**Addendum No. 2 to the Environmental Impact Report
for the
Santa Ana/Garden Grove Fixed Guideway
Project
Orange County, California**

SCH No. 2010051060

February 2017

Figure 1A: Santa Ana/Garden Grove Fixed Guideway Minor Design Modifications Overview

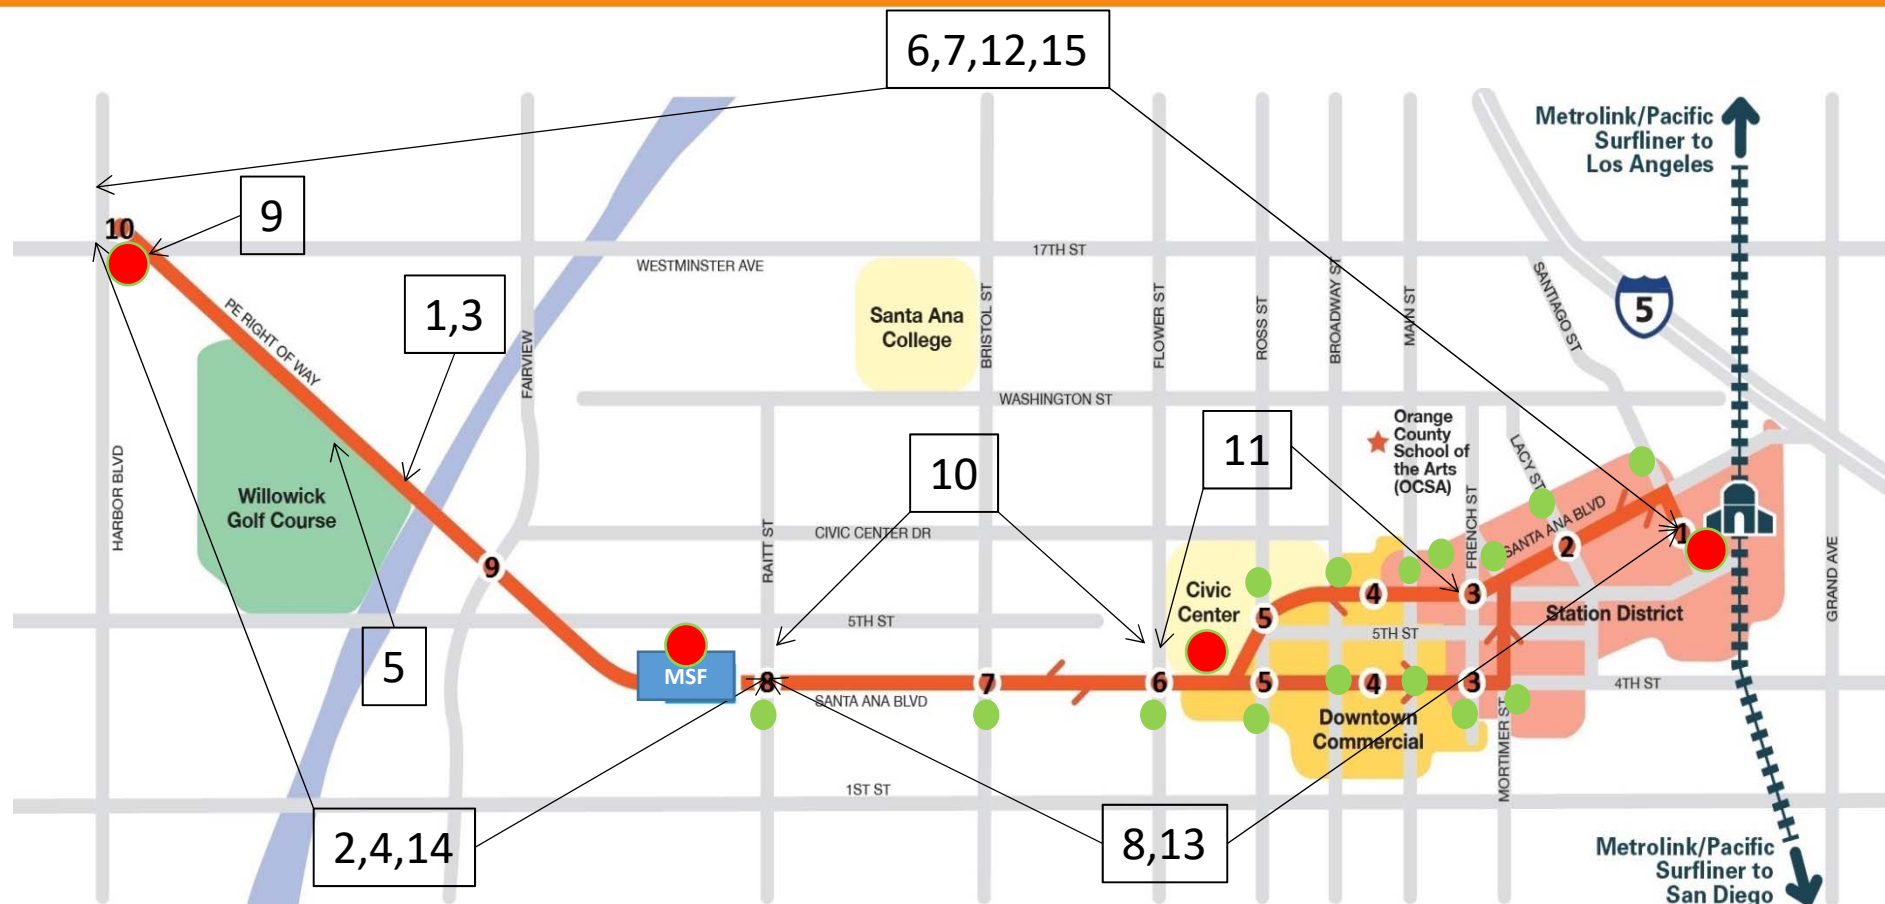
- 1) Reducing the maximum speed within the PE ROW from 45 miles per hour (mph) to 44 mph.
- 2) Implementation of Traffic Signal Priority (TSP) at all traffic signals along the route including at Main Street, Broadway, and Bristol Street.

Figure 2A: Update ID # 2 Track Centerline Repositioning

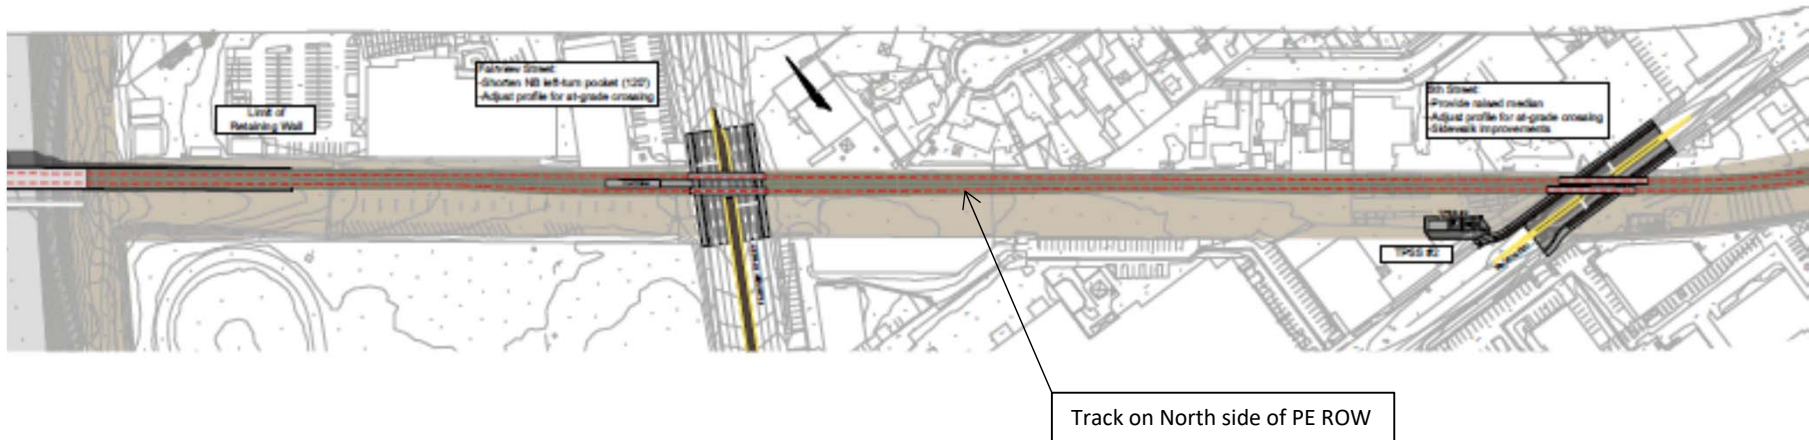
- 1) Track shifted to the center of the PE ROW starting from 140-ft east of Santa Ana River (SAR) Bridge to 5th Street at-grade crossing resulting in a slight track shift to the southern side of the PE ROW between 5th Street at-grade crossing and the Maintenance and Storage Facility (MSF), no private property is required. The Project footprint is not affected by this change.

The proposed modification at 60% design would shift the railroad alignment within the PE ROW. Table K lists the vibration levels calculated by HDR (June 2016) for the 30% design. Only the receptors included within the affected area (PE ROW) are listed.

Figure 10A: Update ID # 12 - Traction Power Substation Locations

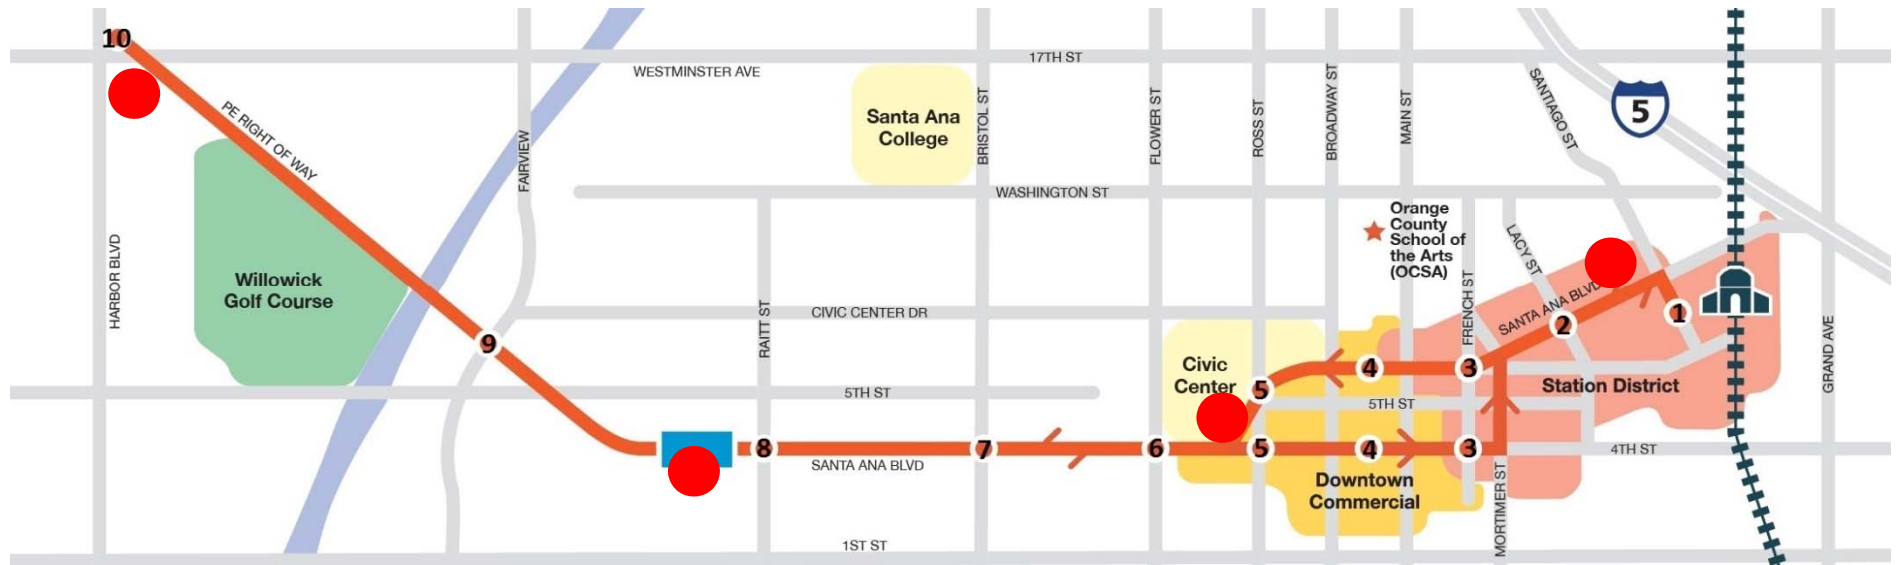
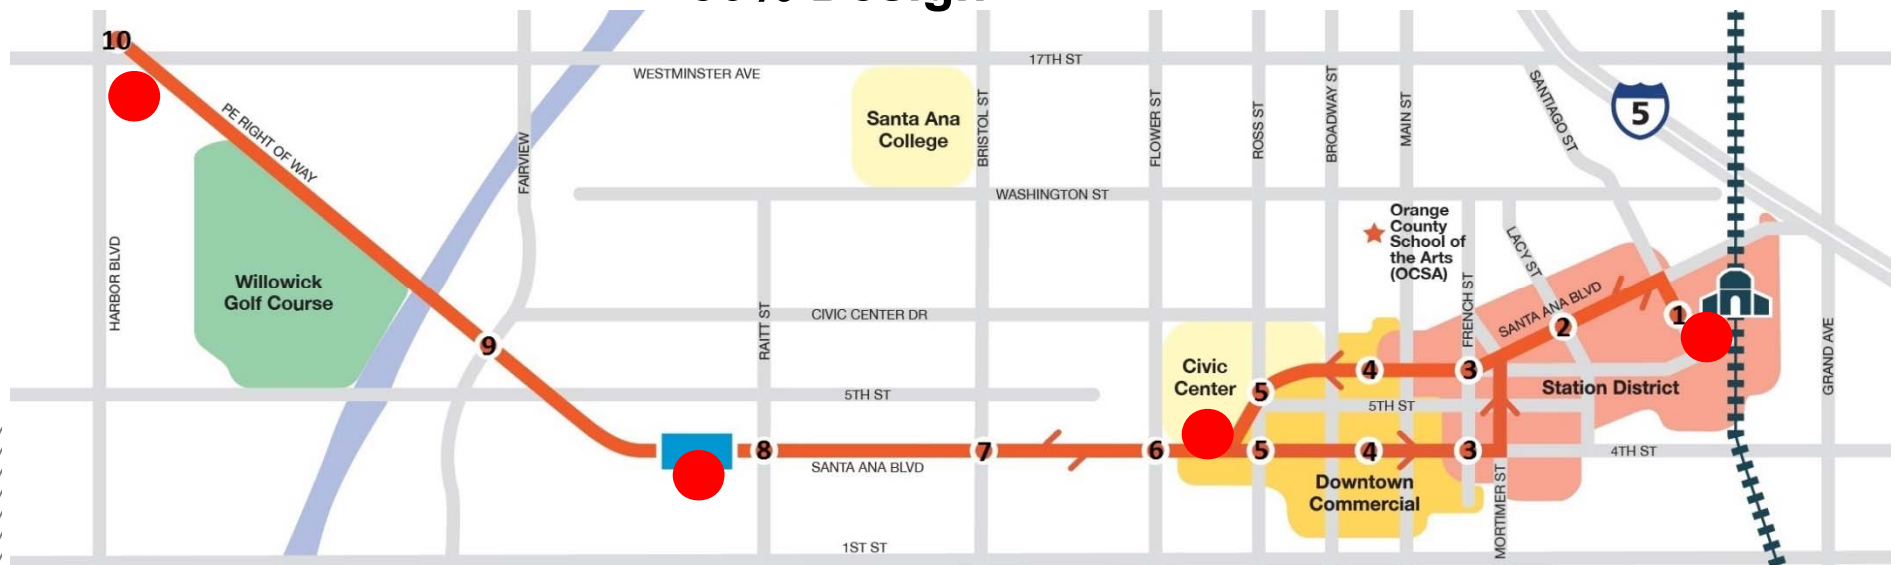
- 2) Revised location of the TPSS unit. 4 formerly proposed at the north east corner of Santa Ana Blvd. and N. Garfield Ave. to the north side of the parking structure at SARTC, adjacent to N. Santiago Street. The Project footprint is not affected by this change.

The 60% design plans move TPSS unit 4 to the Santa Ana Regional Transportation Center (SARTC) on the north side of the parking structure adjacent to Santiago Street. At this location the TPSS unit would be located within 100 feet of the main SARTC structure and 350 feet from the nearest residences.
